QA Review Response

FY15 TOPO-BATHY LIDAR, ELWHA RIVER, WA

TASK ORDER NUMBER: G15PD01145
USGS CONTRACT: G10PC00057

This report explains issues noted in the USGS Quality Assessment Report dated 2016-01-21 and how these have been addressed.

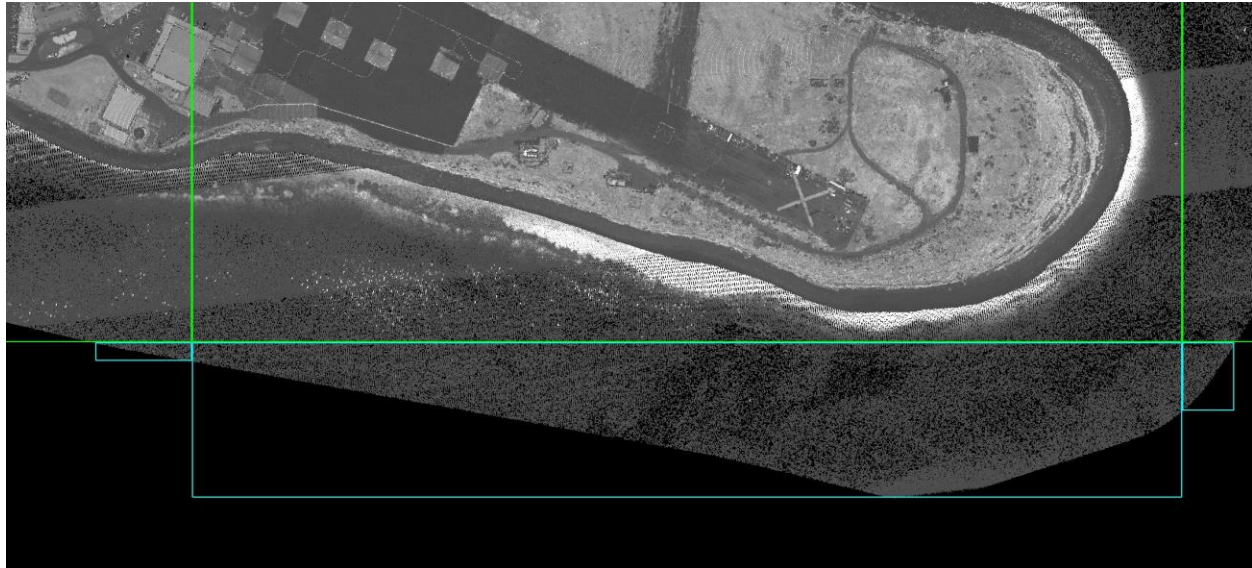
Issue: flightline 00330: red, green & blue values are not populated in point data.

Response: We are unable to color this flight line using the colorization technique used for the other lines. Since this was not a requirement for the project, no further action has been taken.

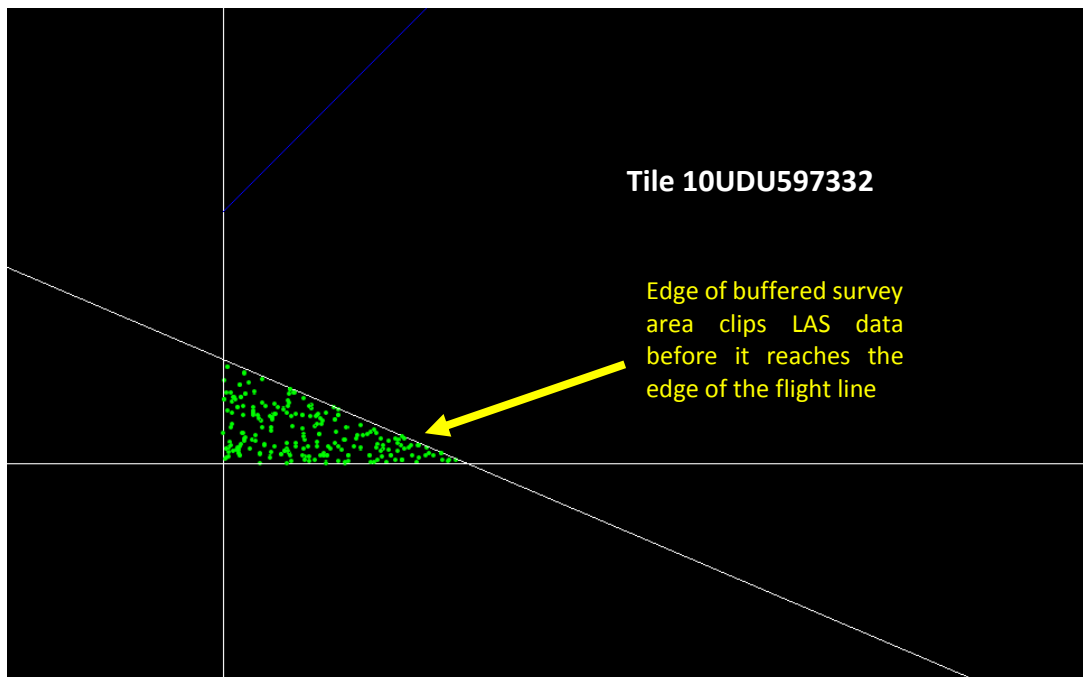
Issue: all flight lines: Legacy point count (0) does not match 1.4 point count.

Response: From presentations at ILMF our understanding is that the Legacy Point count should be 0. No action taken.
